# FOX POINTE SECOND ADDITION

AN ADDITION TO WICHITA, SEDGWICK COUNTY, KANSAS

Re: S/D 95-74 - FOX POINTE SECOND ADDITION (Final Plat)

**STAFF REPORT**

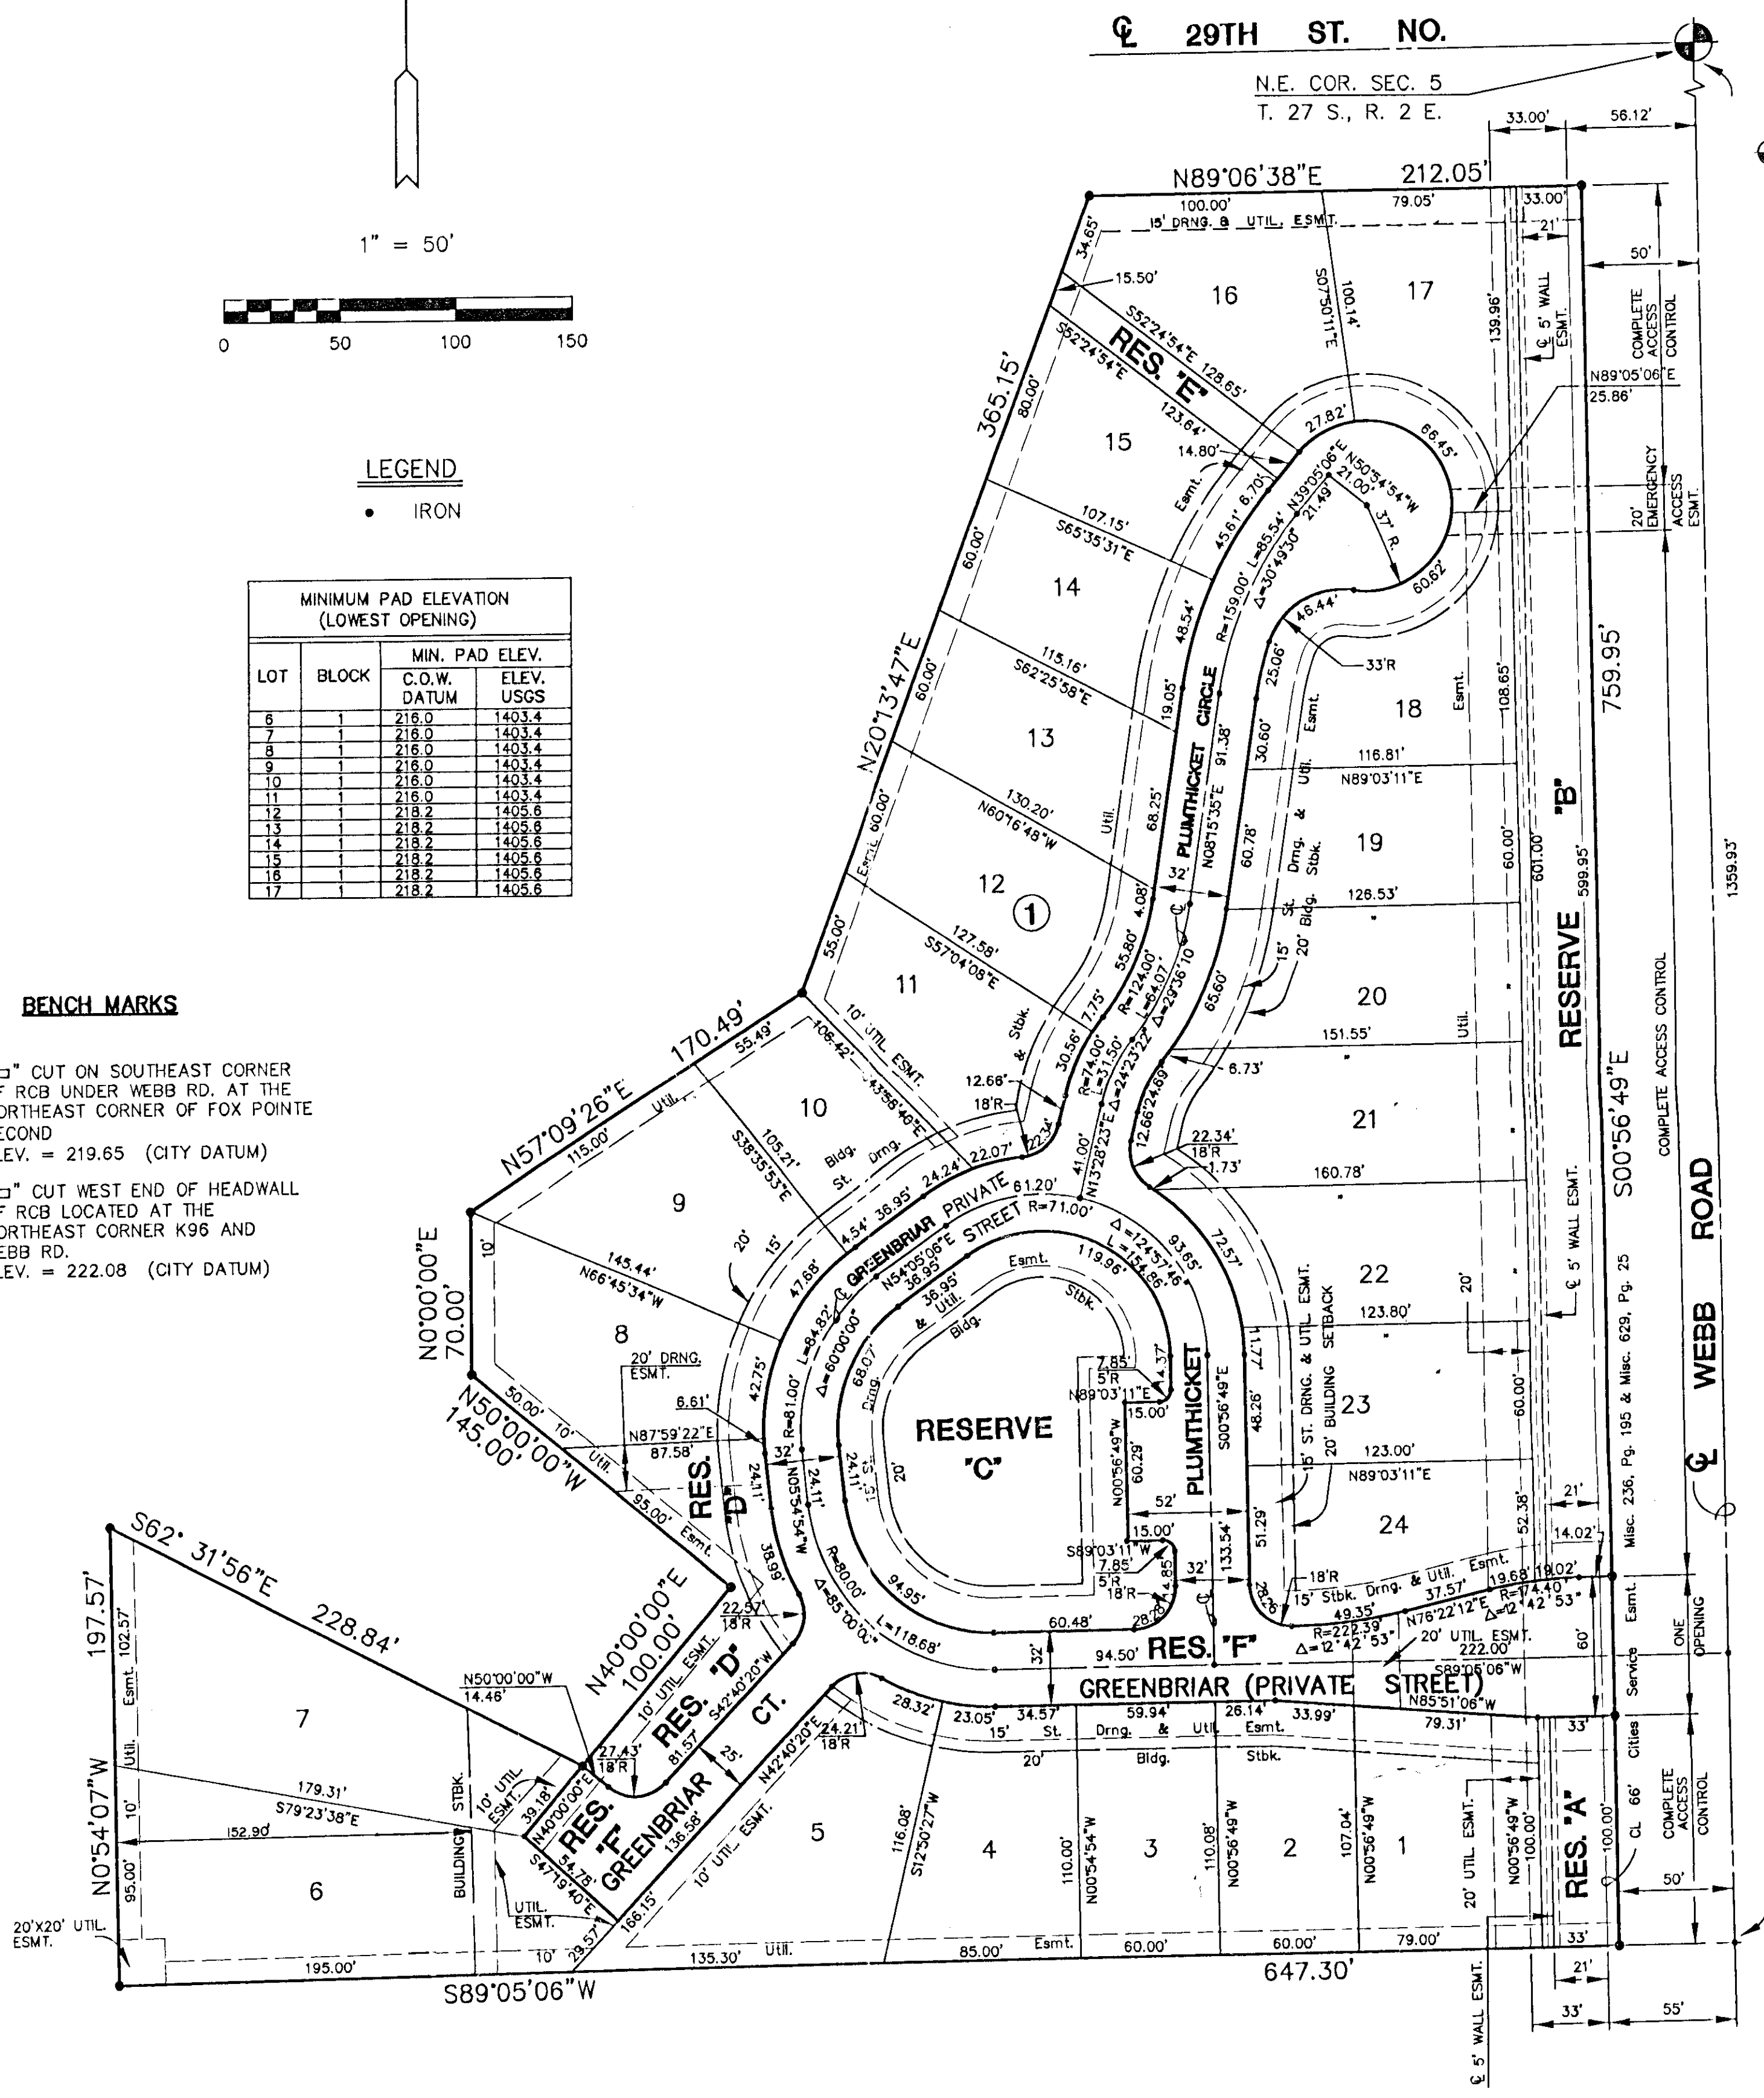
~~C.~~ *shown*  
As this property is establishing minimum building pad elevations, the face of the final plat tracing shall reference the location and elevation of permanent on-site and off-site benchmarks. Section 5-402(N).

~~G.~~ On the final plat tracing, the surveyor's text shall be corrected to note that the drainage easement being vacated appears to have been recorded on Film 1131 not 131. *OK*

~~I.~~ *Ed Resa*  
On the final plat tracing, the text in the plat's text concerning the wall easement shall be corrected. The word "The" needs to be capitalized at the beginning of the sentence and the word "the" inserted toward the end of the sentence between...to cross the wall easement.

DB: As indicated by City Engineering, the final plat tracing shall indicate an enlarged drainage easement along the plat's northern line. Further, an off-site drainage easement will be required and needs to be provided by separate instrument. This easement shall be submitted to Engineering for review, then to Planning for recording with the plat.

- CC. The final plat shall indicate the utility easements requested by K.G.& E.-Gas and K.G.& E.-Electric which are indicated on the enclosed "marked" copy of the plat.

- DD. As indicated by City Engineering, the final plat tracing shall indicate an enlarged drainage easement along the plat's northern line. Further, an off-site drainage easement will be required and needs to be provided by separate instrument. This easement shall be submitted to Engineering for review, then to Planning for recording with the plat.
